U.S. Department
Of Transportation
**Federal Highway
Administration**

Refer to: HNG-14/SS-78

Geometric and Safety Design Acceptance Letter SS-78

D		
C		
B		
A		
REV.	DATE	DESCRIPTION
SMI STEEL - ARKANSAS		SCALE: 1:1
COLD DRAWING 2.0#/FT SIGN POST.		DRAWN BY: JEM DATE: 10/30/97
		COLDSP2-0

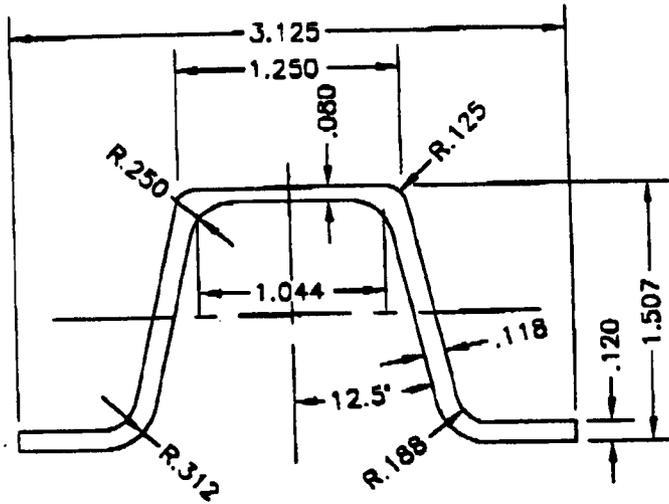
This is in reply to your January 13 letter to Mr. Henry Rentz regarding your company's steel flanged channel sign posts. You requested that your 3.0-kg/m (2.0-lb/ft) and 3.7-kg/m (2.5-ol/ft) posts meeting the requirements of ASTM A499-81 (re-rolled rail steel), Grade 60, be found acceptable for use on the National Highway System (NHS) where breakaway supports are required. You requested that one or two posts be acceptable within a 2.1-meter span when buried directly into strong soil, and up to 3 posts be found acceptable within a 2.1meter span when used with an overlap splice. In addition, you indicated that the spliced posts require soil plates on the stubs when used in "weak" soil. Drawings of the post sections are enclosed. You described your lap-splice hardware as follows:

Your company's posts, fastener hardware, and soil plates are equivalent to breakaway supports previously found acceptable. Therefore, your company's 3.0-kg/m and 3.7-kg/m U-channel sign supports, conforming to ASTM A499-81, Grade 60 steel and the configurations outlined in the table above, are acceptable for use on the NHS, subject to the conditions cited, when requested by a State.
